1A & 1B VALLEY ROAD
59 - 63 TRAFALGAR AVENUE
LINDFIELD

SSD APPLICATION - DESIGN REPORT

APPENDIX AP6. RTS RFI RESPONSE

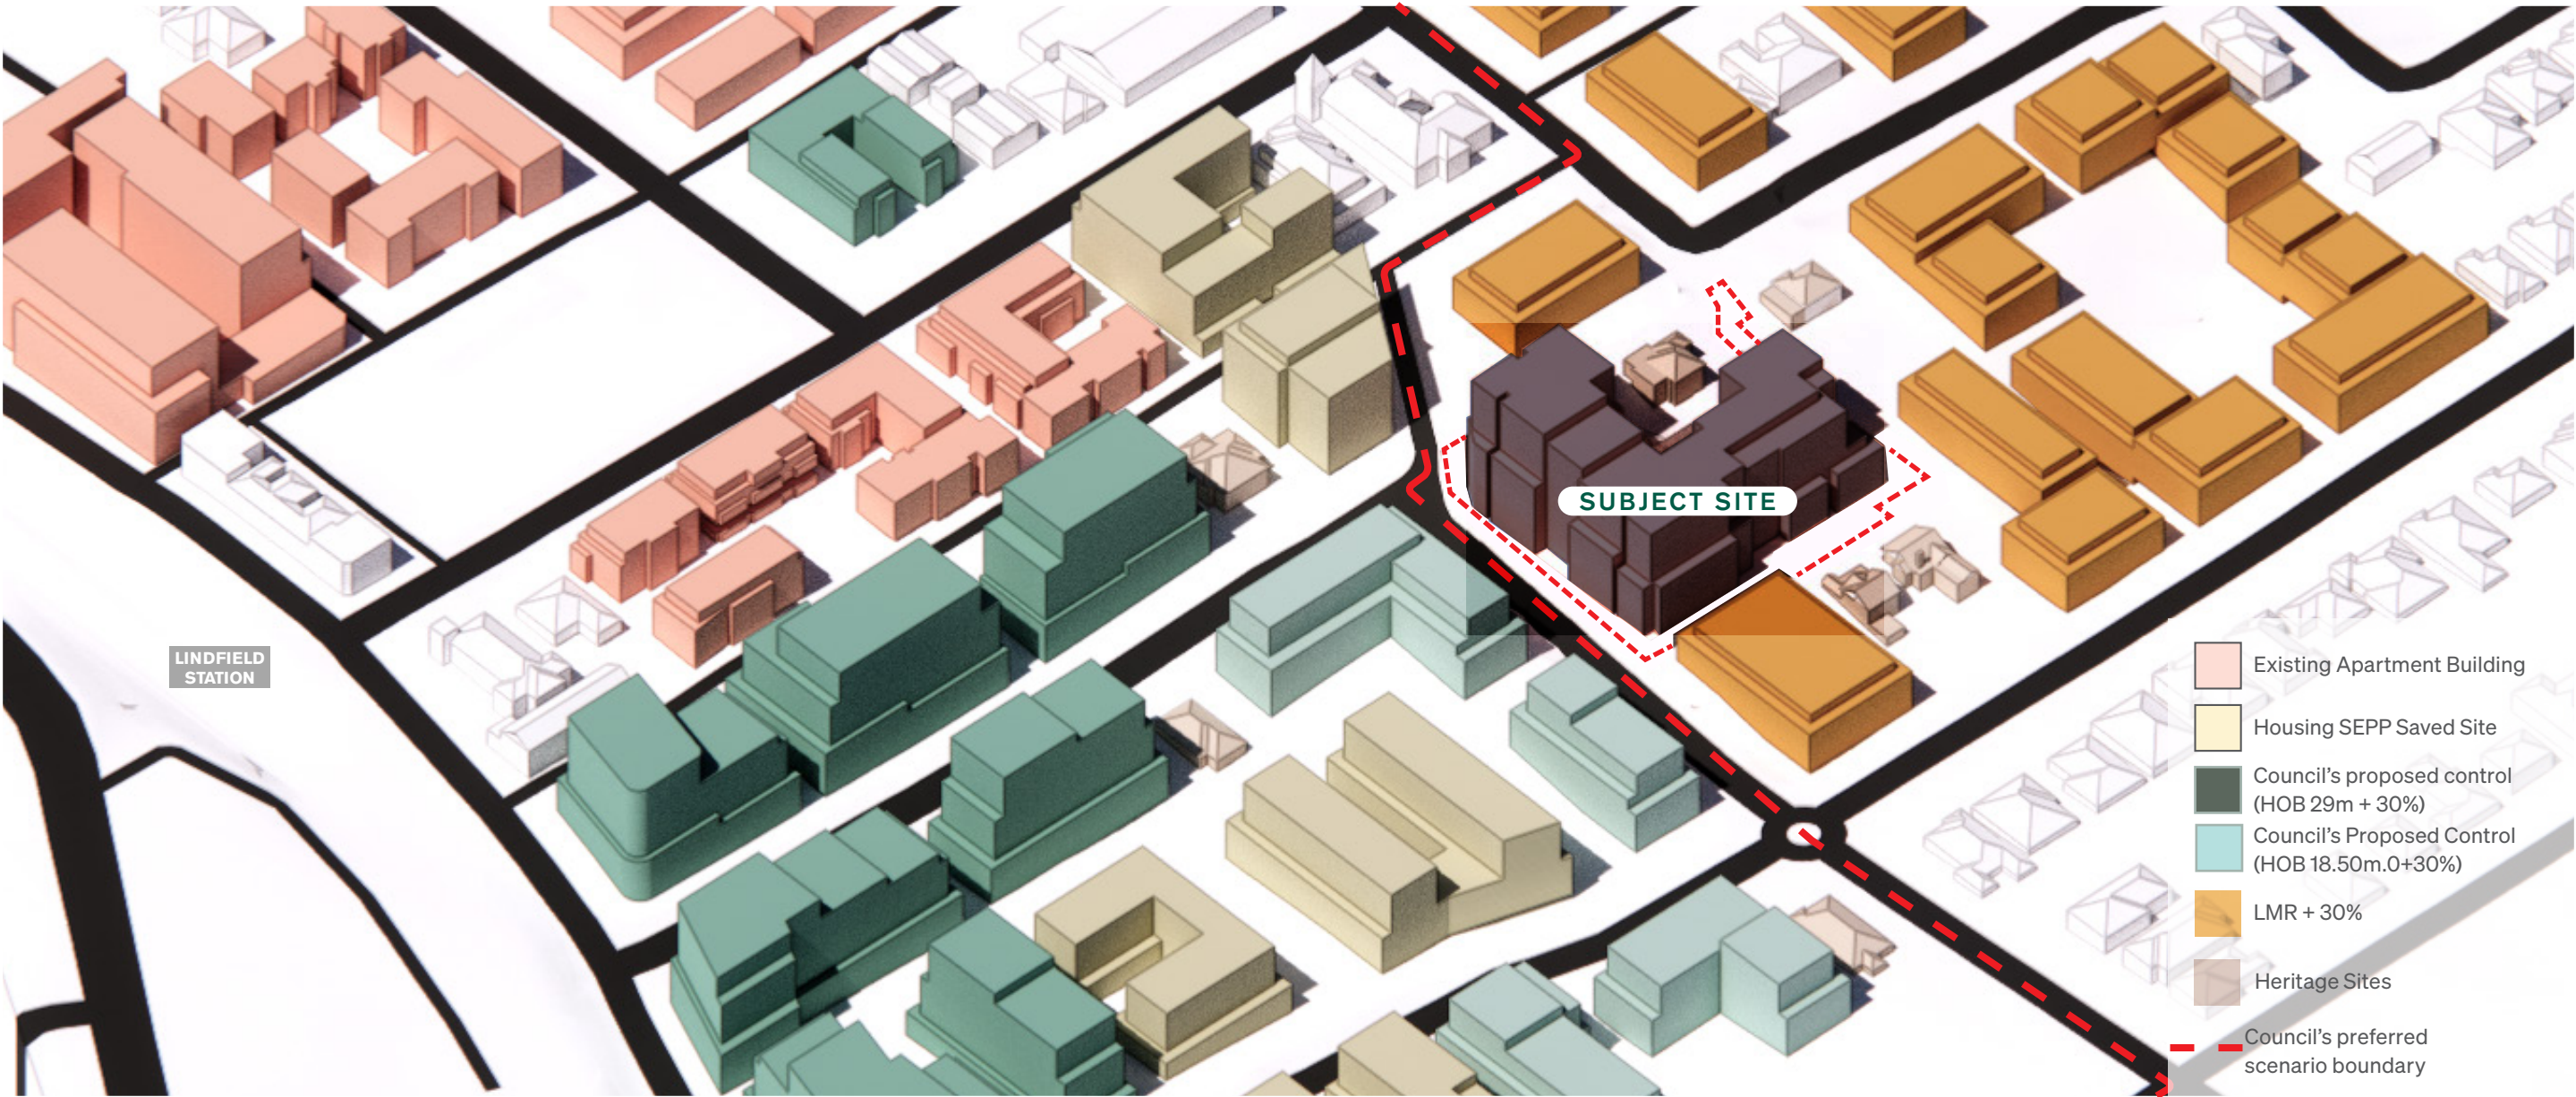
1. Demonstrate how the proposal is consistent with the desired future character of the area, including alignment with State and local plans and strategies as well as further analysis and design response to the specific local character of the area.

The subject site is positioned between a potential future TOD context area and the LMR +30% zone. The proposed massing provides a gradual transition from higher to medium building heights, with setbacks that respond to the change in zones. Additional upper-floor setbacks have been incorporated to enhance amenity for the southern neighbouring dwellings, ensuring the design aligns with both the desired future character and the local context.

BUILDING HEIGHT

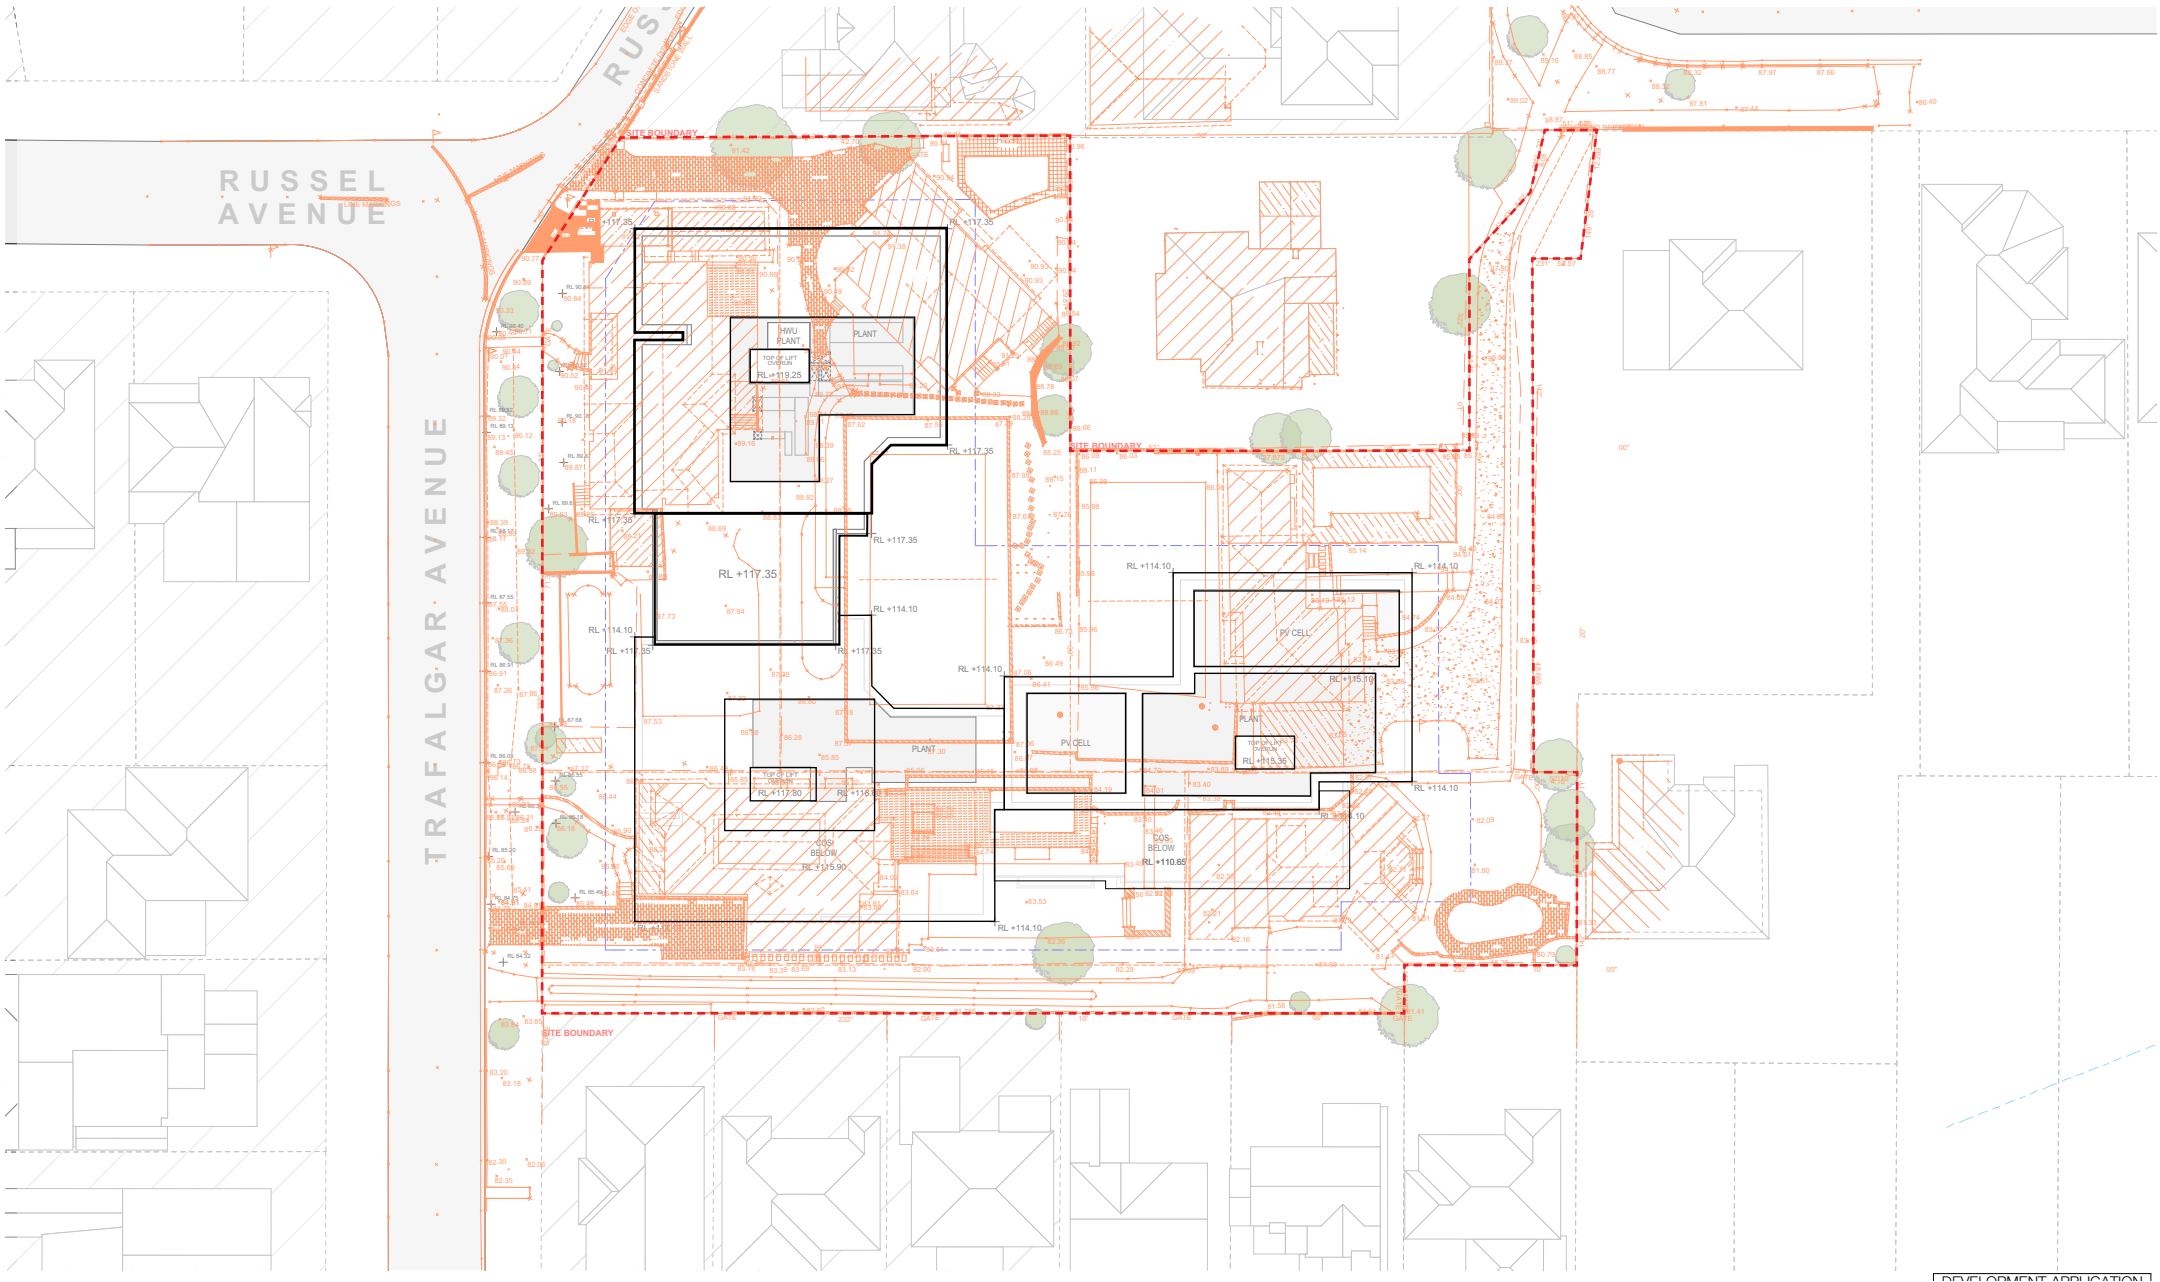
5. Provide further detailed plans and documentation in relation to the proposed building height, and how it corresponds with the existing ground level across the site to enable an accurate assessment of compliance with the maximum permissible building height under the Housing SEPP. The proposal should be refined as necessary to be compliant with the maximum permissible building height of 28.6m.

Although there are some height exceedances on the roof, these are the result of a built form which responds to the steep slope in topography and seeks to maintain solar access to the southern properties. Updated drawings now include survey plans aligned with building RLs and shadow analysis. From the exhibited scheme there is a reduction from the top of the building. Refer to architectural drawing DA310, DA311 and DA505.

BUILDING HEIGHT

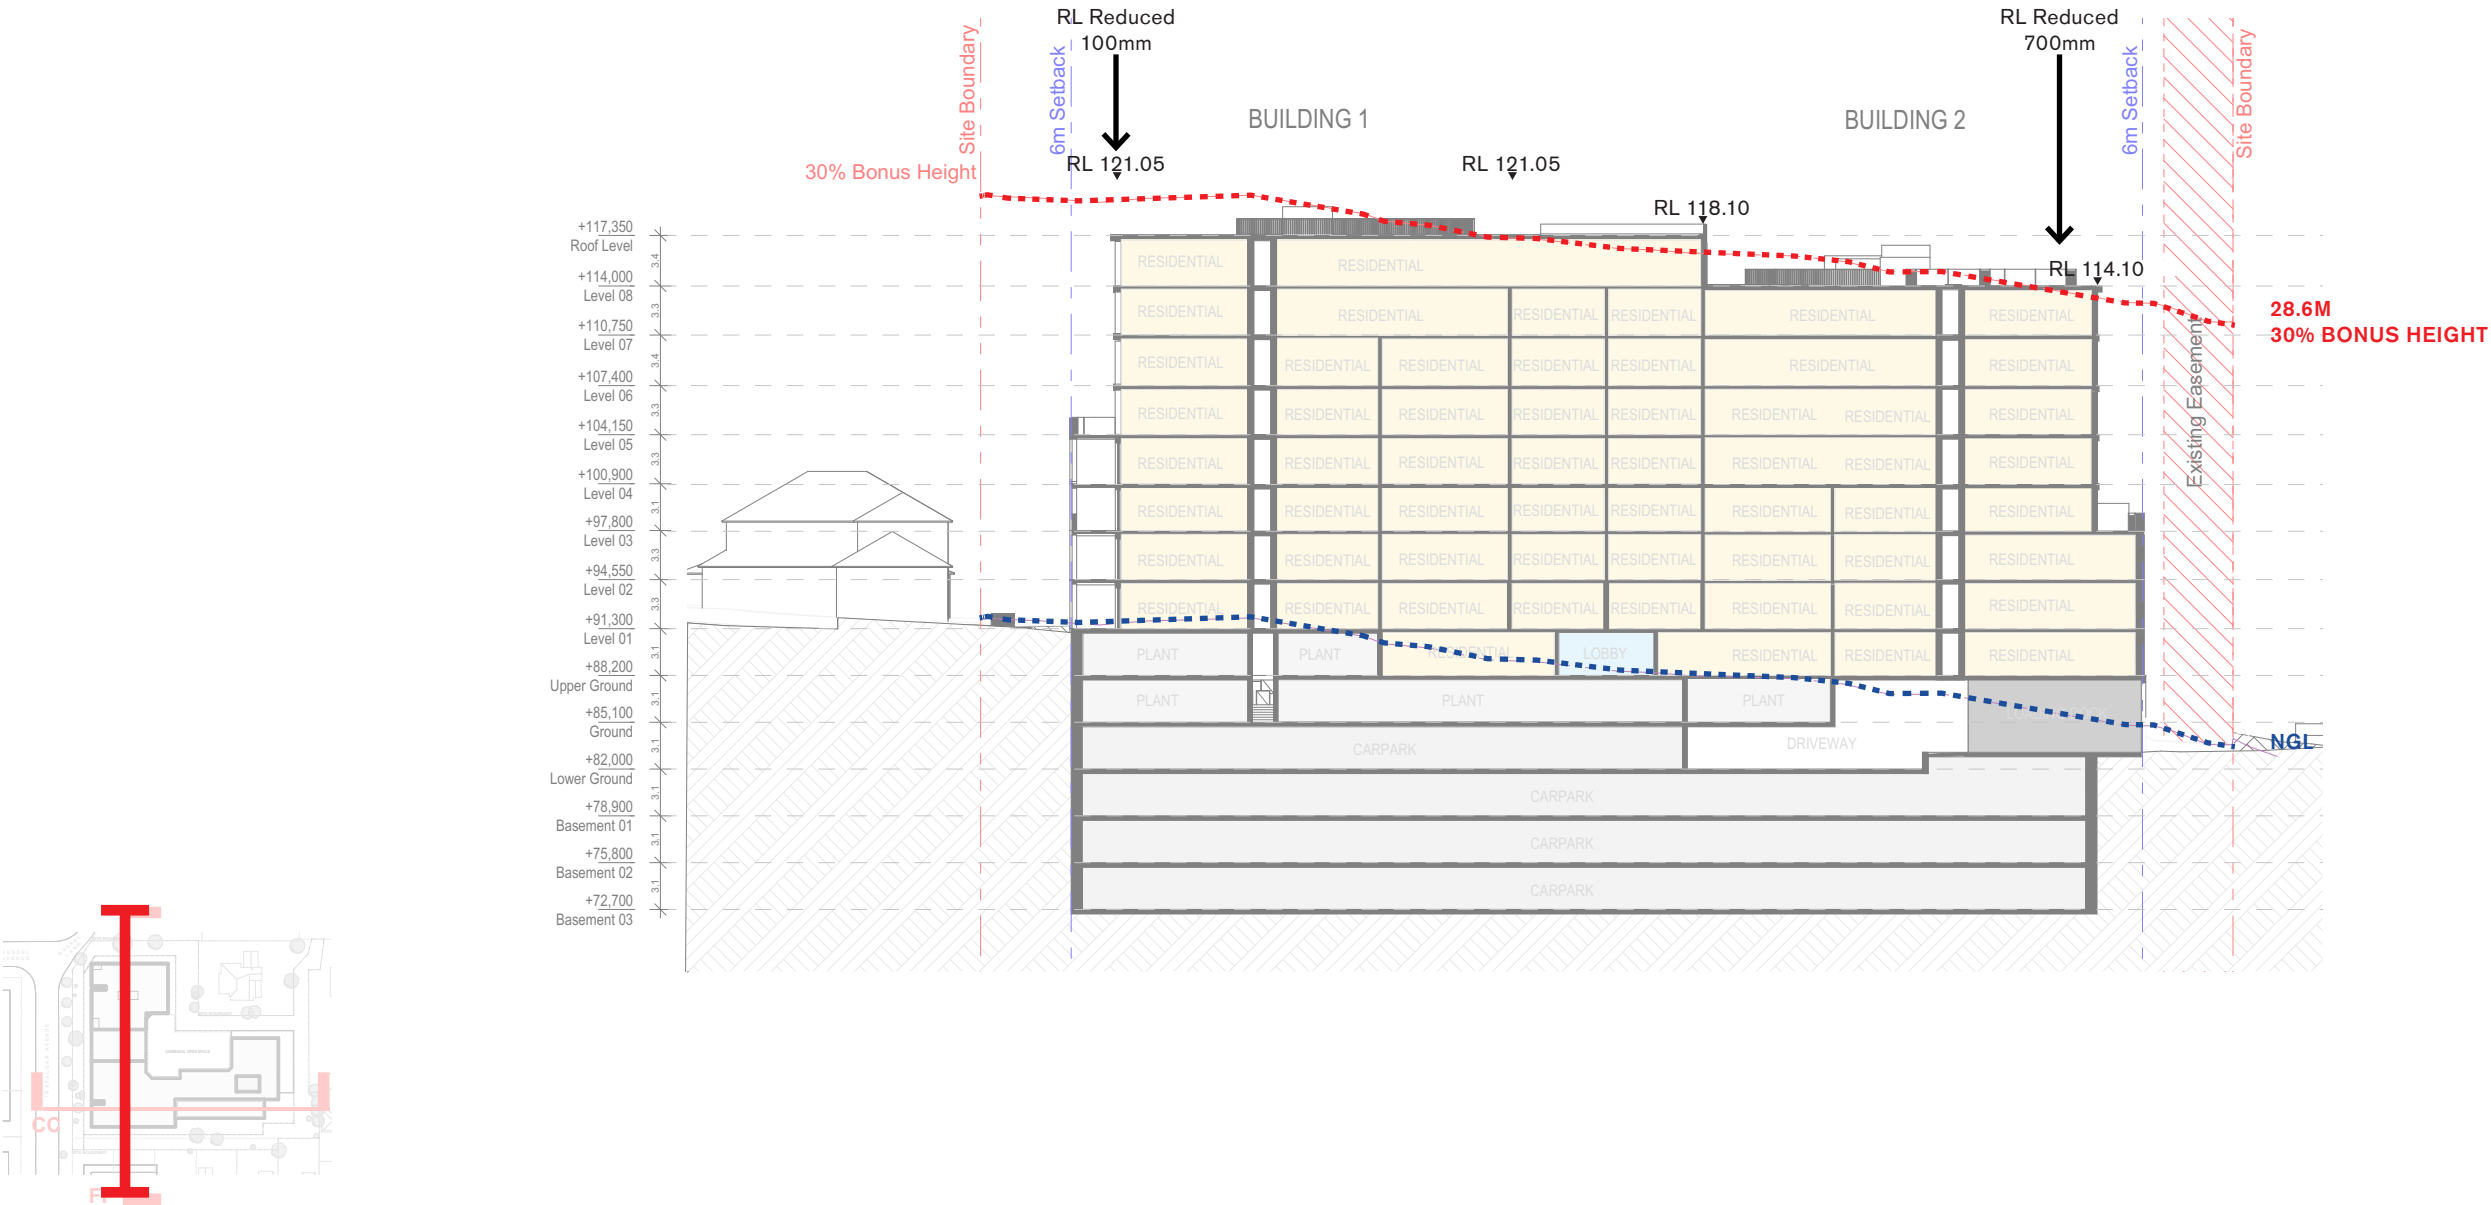
5. Provide further detailed plans and documentation in relation to the proposed building height, and how it corresponds with the existing ground level across the site to enable an accurate assessment of compliance with the maximum permissible building height under the Housing SEPP. The proposal should be refined as necessary to be compliant with the maximum permissible building height of 28.6m.

Although there are some height exceedances on the roof, these are the result of a built form which responds to the steep slope in topography and seeks to maintain solar access to the southern properties. Updated drawings now include survey plans aligned with building RLs and shadow analysis. Refer to architectural drawing DA310, DA311 and DA505.

SECTION CC

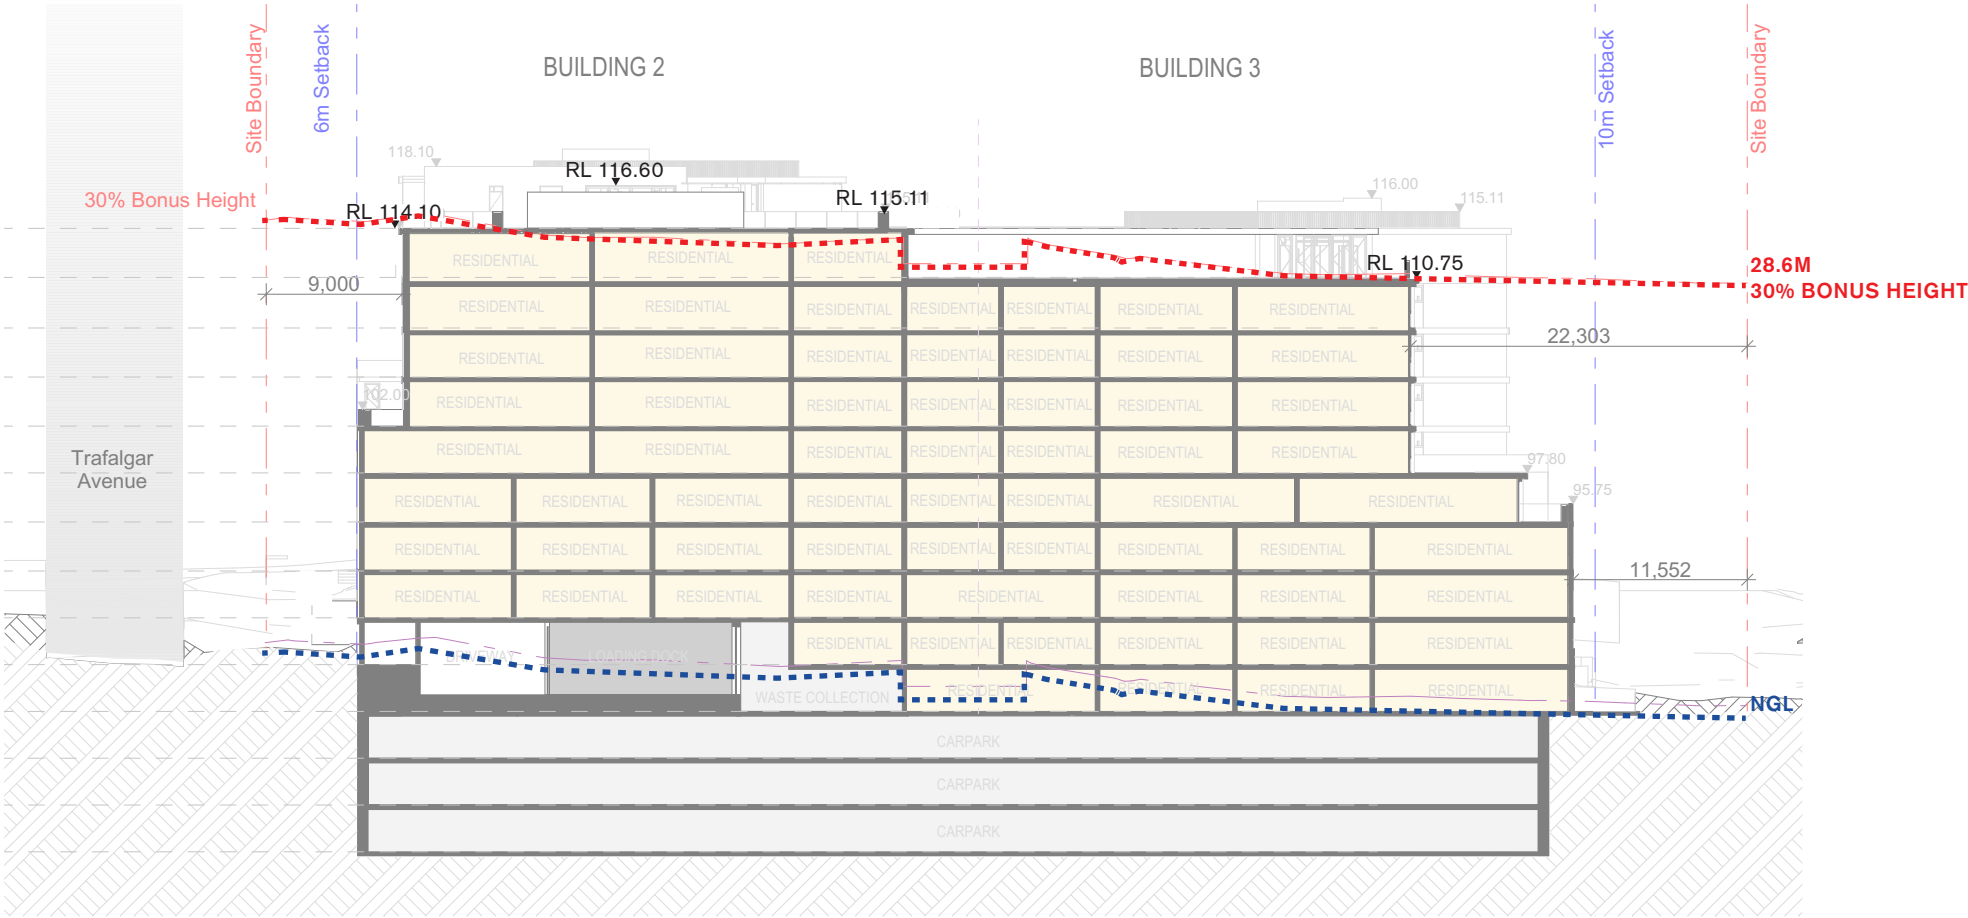
5. Provide further detailed plans and documentation in relation to the proposed building height, and how it corresponds with the existing ground level across the site to enable an accurate assessment of compliance with the maximum permissible building height under the Housing SEPP. The proposal should be refined as necessary to be compliant with the maximum permissible building height of 28.6m.

Although there are some height exceedances on the roof, these are the result of a built form which responds to the steep slope in topography and seeks to maintain solar access to the southern properties. Updated drawings now include survey plans aligned with building RLs and shadow analysis. Refer to architectural drawing DA310, DA311 and DA505.
